Agenda Item # 3 SUB-003028-2024

- Subdivision approval to create one (1) legal lot of record from one (1) metes-and-bounds parcel.

CROSBY ADDITION SUBDIVISION

DETAIL SITE PLAN

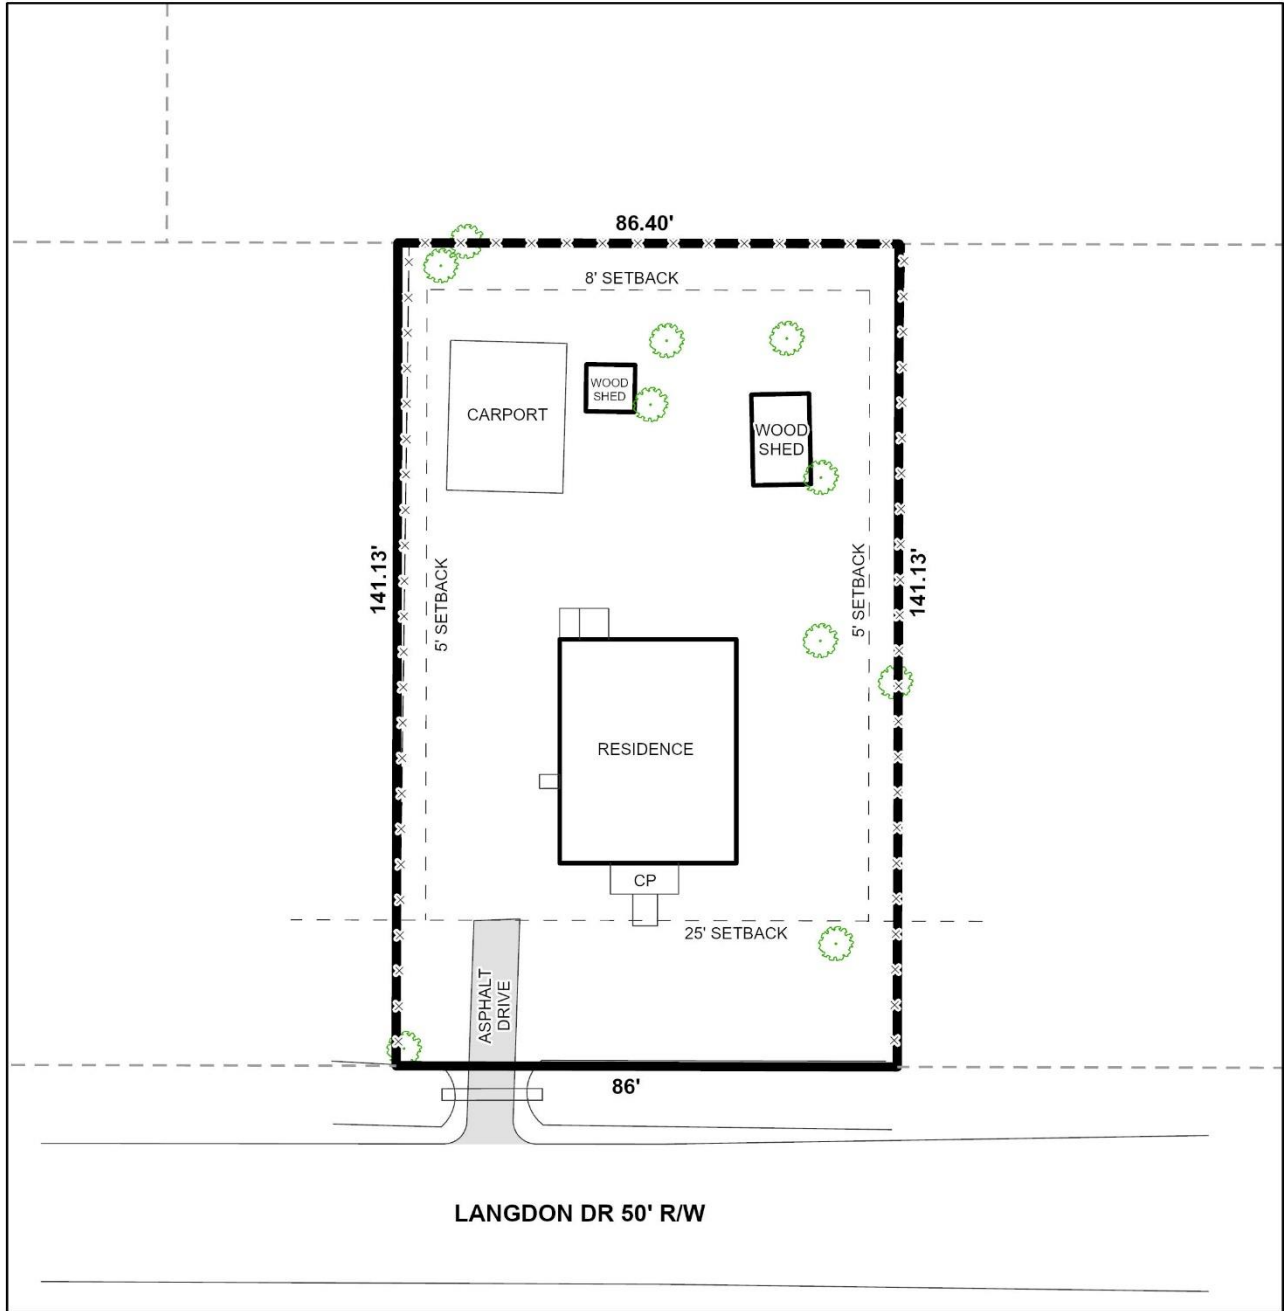
The site has frontage on Langdon Drive, a minor street without curb and gutter requiring a 60-foot right-of-way width. The preliminary plat depicts a 50-foot right-of-way width at this location. If approved, revision of the plat to illustrate dedication sufficient to provide 30 feet from the centerline of Langdon Drive should be required unless a waiver of Section 6.B.9. of the Subdivision Regulations is granted by the Planning Commission.

The lot, as proposed, exceeds the minimum size requirements for lots served by public water and sanitary sewer in an R-1 Suburban, but its size is not labeled in square feet and acres on the survey. If approved, this information should be provided on the Final Plat, adjusted for any required dedication; or placement of a table on the Final Plat with the same information will suffice.

A 25-foot front yard setback is illustrated along Langdon Drive on the survey, in compliance with Section 64-2-5.E. of the Unified Development Code (UDC) for lots in the R-1 Suburban district. If approved, this information should be retained on the Final Plat, adjusted for any required dedication.

Five (5)-foot side yard setbacks and an eight (8)-foot rear yard setback are illustrated along side and rear property lines, which is not required by the Subdivision Regulations. As such, removal of the side and rear setbacks from the Final Plat should be required.

1. Revision of the plat to illustrate dedication sufficient to provide 30 feet from the centerline of Langdon Drive, or Planning Commission approval of a waiver of Section 6.B.9. of the Subdivision Regulations;

2. Provision of the lot's size in square feet and acres on the Final Plat, adjusted for any required dedication, or provision of a table on the Final Plat with the same information;

3. Retention of the 25-foot minimum front yard setback along Langdon Drive on the Final Plat, adjusted for any required dedication;
4. Removal of the side and rear yard setback lines from the Final Plat;
